ski-doo[®]

2010 Technical Update Book

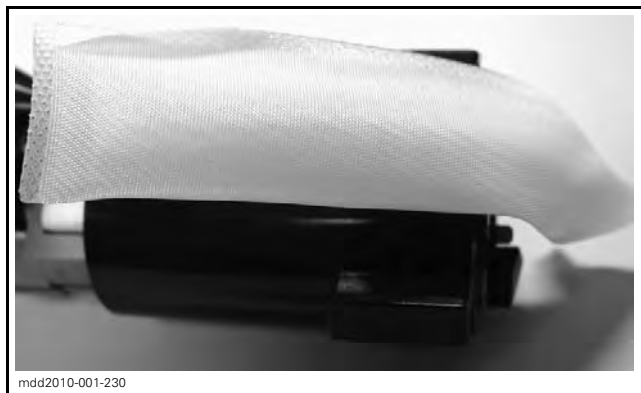
The inline final filter and the in-tank pick-up inlet screen filter have been available separately, however the internal high pressure jet pump 60 micron filter was not available until the release of Ski-Doo service bulletin 2009-18. This bulletin has full information on the replacement procedure for this internal high pressure jet pump filter and the part numbers needed to perform the filter replacement procedure. **If the fuel system has been contaminated from poor quality or contaminated fuel, the cleaning and repair of the snowmobiles fuel system and any consequential damage may not be covered under warranty.** The new larger volume filter mentioned on Service Bulletin 2009-18, (P/N 415 129 451), will work on 2008 and newer 600sdi's in Rev-XP & Rev-XU chassis's as well as all 1200 4-TEC's and E-TEC's.

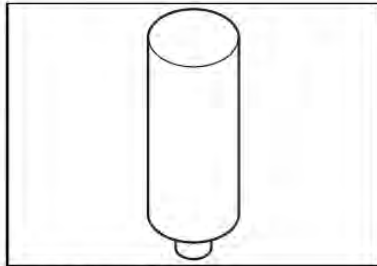
Rotary Valve Bearing Pusher
P/N 420 876 501 Recommended
717, 787 & 787 RFI engines

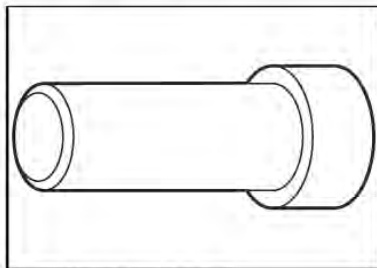
Crankshaft Protector
P/N 420 876 557 Recommended
717 / 787 RFI / 800R / 800 HO

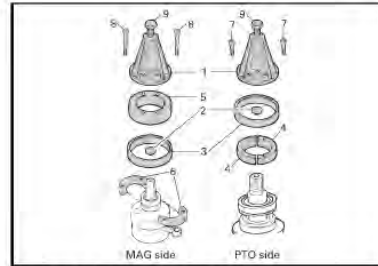
Flywheel puller
P/N 420 976 235 Recommended
247, 787, 787 RFI, 947 & 947 DI engines
Replacement bolt P/N 529 035 549.

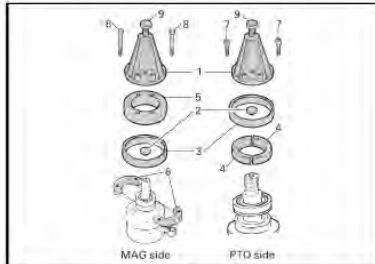
HALF RING PULLER
P/N 420 977 475 Recommended
717 / 787 RFI engines

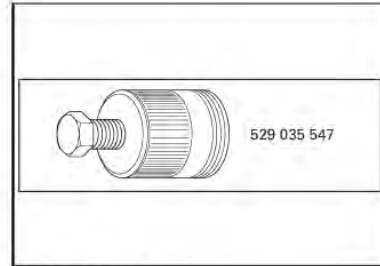
Sleeve kit 20 mm
P/N 529 035 542 **Mandatory**
717, 787 RFI, 600, 800HO
Used with 529035503

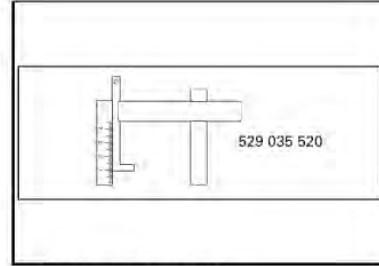
Fuel pressure gauge
P/N 529 035 591 Recommended
787 RFI, 793 SDI & 4-TEC engines
Replaced by 529 035 709. Spare plastic clip P/N 275500429
